Serial: NPD-NRC-2008-067
December 26, 2008

**SHEARON HARRIS NUCLEAR POWER PLANT, UNITS 2 AND 3
DOCKET NOS. 52-022 AND 52-023
RESPONSE TO REQUEST FOR ADDITIONAL INFORMATION LETTER NO. 030 RELATED TO
BASIC GEOLOGIC AND SEISMIC INFORMATION**

**Shearon Harris Nuclear Power Plant Units 2 and 3
Response to NRC Request for Additional Information Letter No. 030 Related to SRP
Section 02.05.01 for the Combined License Application, dated October 14, 2008**

Onshore and Offshore
 Late Triassic to Early Jurassic Basins
 in the Eastern United States
FIGURE 2.5.1-210 (Revised)

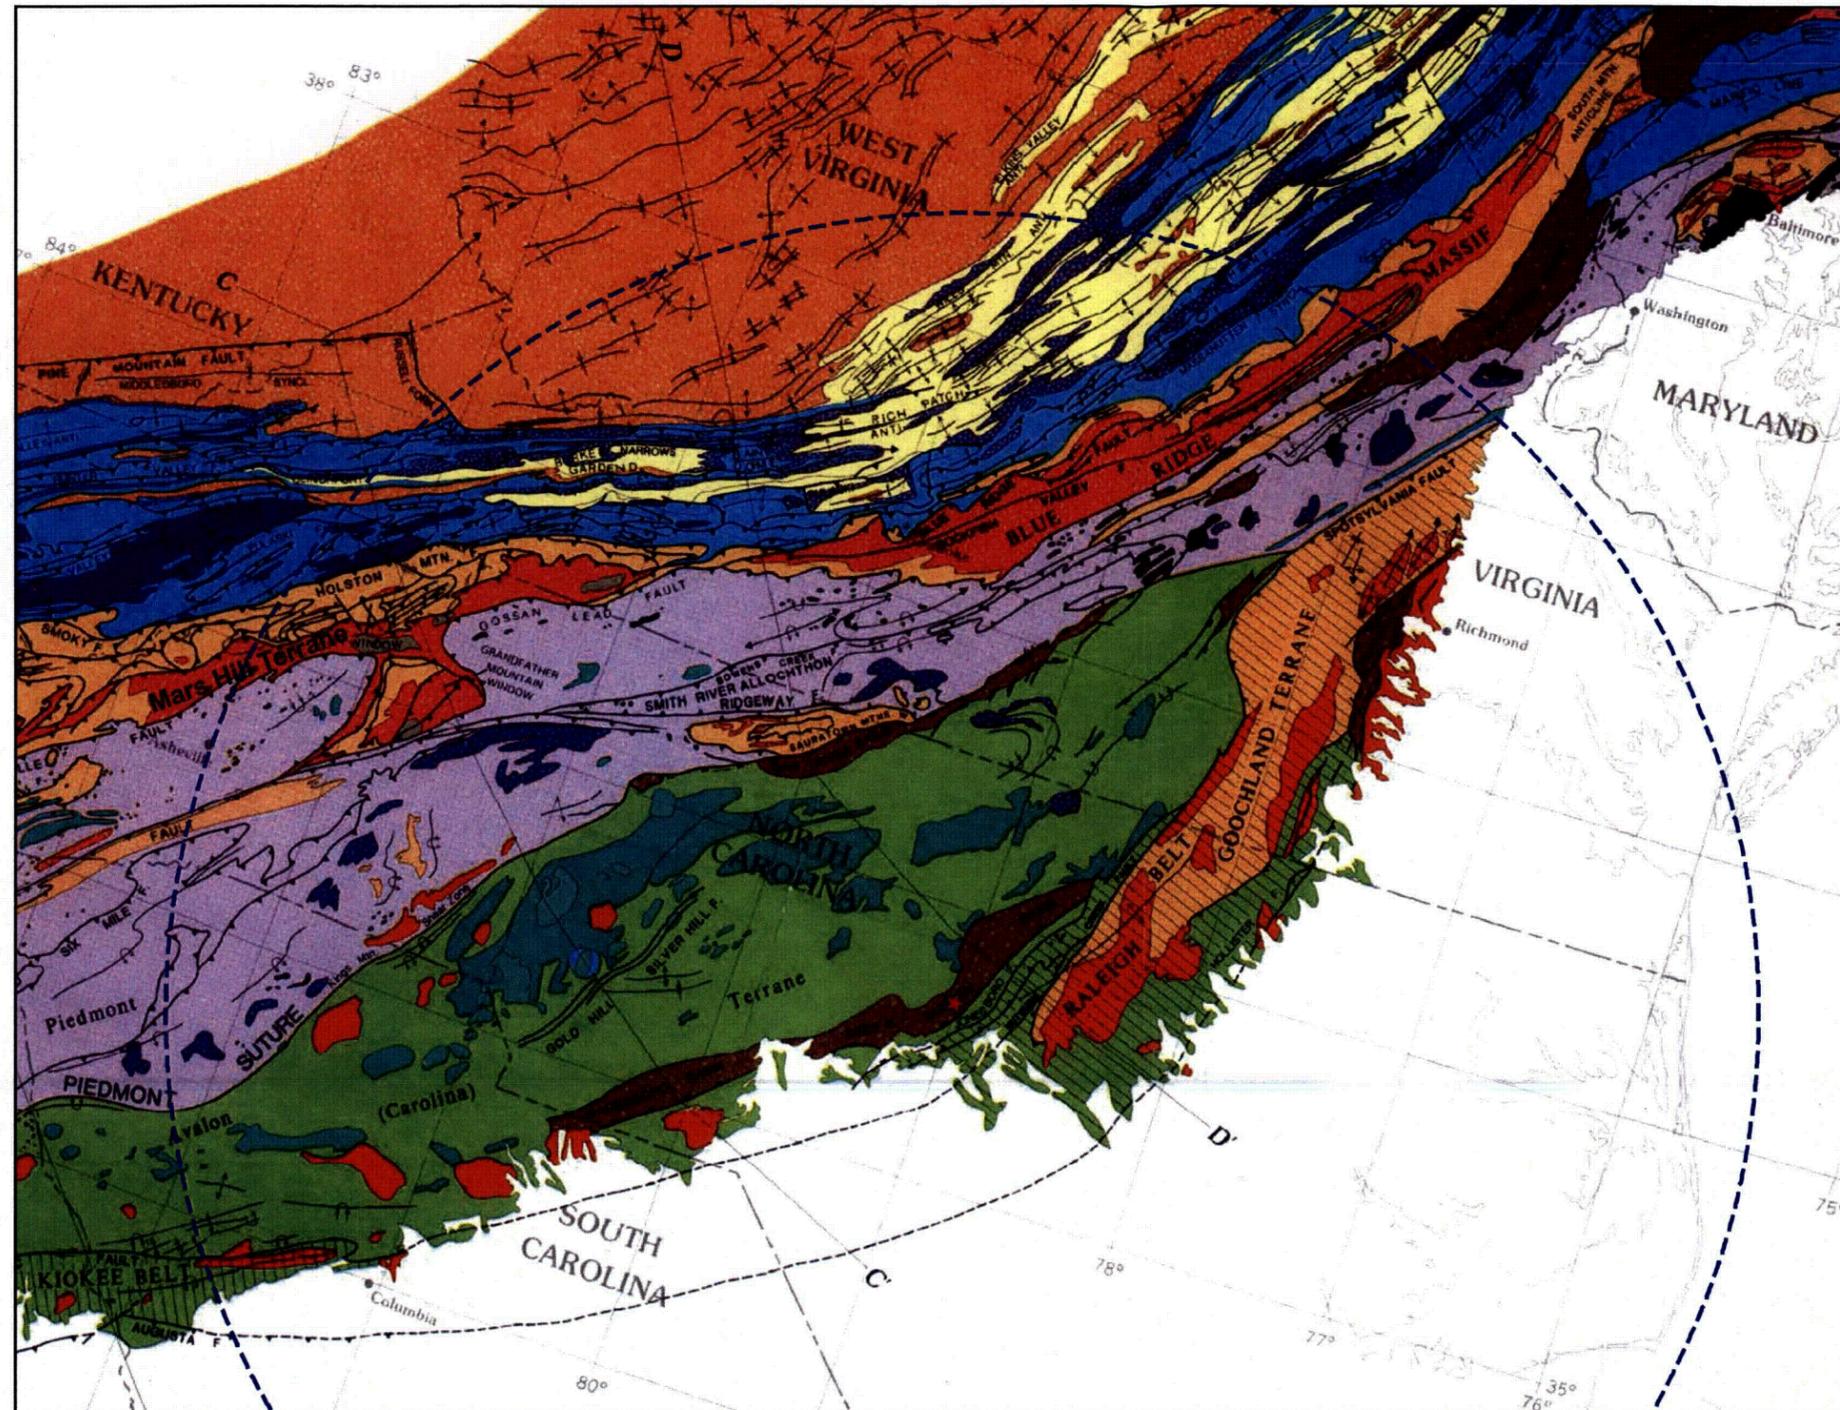
- d) The FSAR cites Figure 2.5.1-210. The explanation on the figure does not correspond to patterns on map. Please revise the explanation on the figure to match the map.

- d) Figure 2.5.1-210 has been revised so that the explanation matches the patterns on the map.
- e) The Coastal Plain sediments are referred to in FSAR Section 2.5.1.1.3.1.2.4 in order to define the borders of the Piedmont Province. The first two paragraphs of this section will be modified in a future revision to clarify this insertion.

Tectonic Map of the Central Appalachians
 Showing Locations of
 Regional Cross Sections C-C' and D-D'
 FIGURE 2.5.1-211 (Revised)

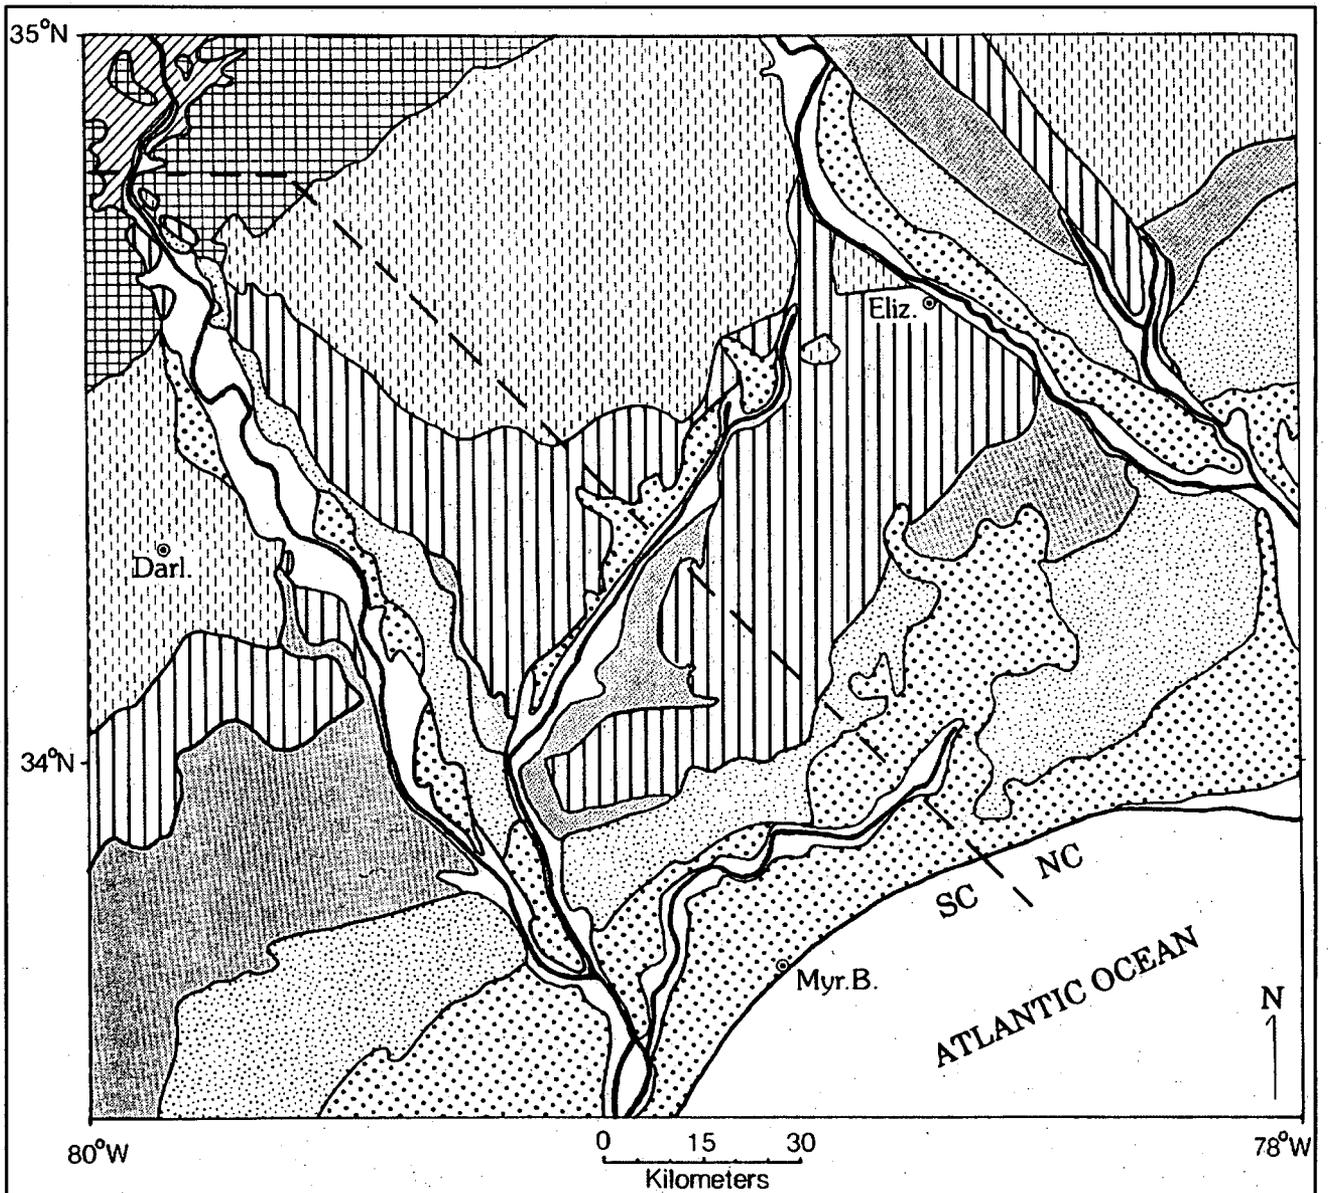
c) Figure 2.5.1-211 shows several regional faults located within the 200 mile radius of the site whose age of movement are not indicated on the figure legend nor are there discussions of these faults provided in the text. Please provide discussion of these faults and the likely age of movement. These faults include: Nutbush Creek fault, Augusta fault, Modoc zone, faults in the vicinity of the Sauratown Mtn Window, the Gold Hill and Silver Hill faults.
